# Access Compliance Report

## Public Rights-of-Way

### (Curb Ramps)

Intersection ID: 48945	Main Street: DAVID_JENNINGS_AV	Cross Street: CALDWELL_RIDGE_PY	Location:	N
ADA ID: 8A21C2B87215	Ramp Type: Combination2	Initial Pass/Fail: Fail	Overall Compliance: No	Severity Score: 10

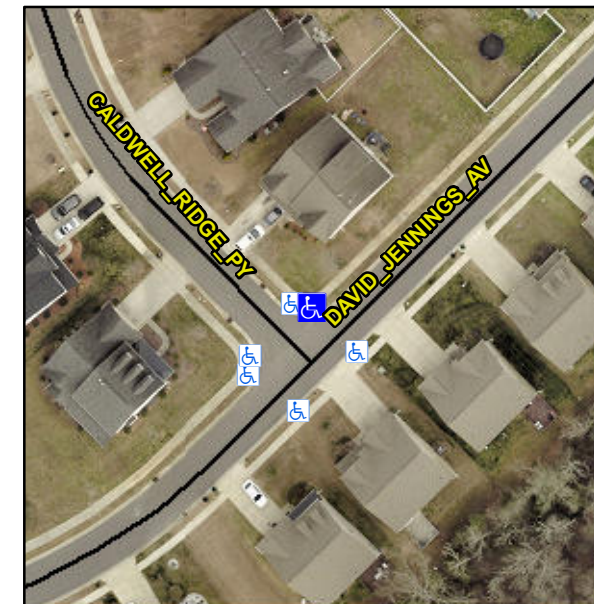
**RT RP < 5%**

**Not Found, R304.5.1, R304.5.3**

**Remove & Replace Entire Ramp.**
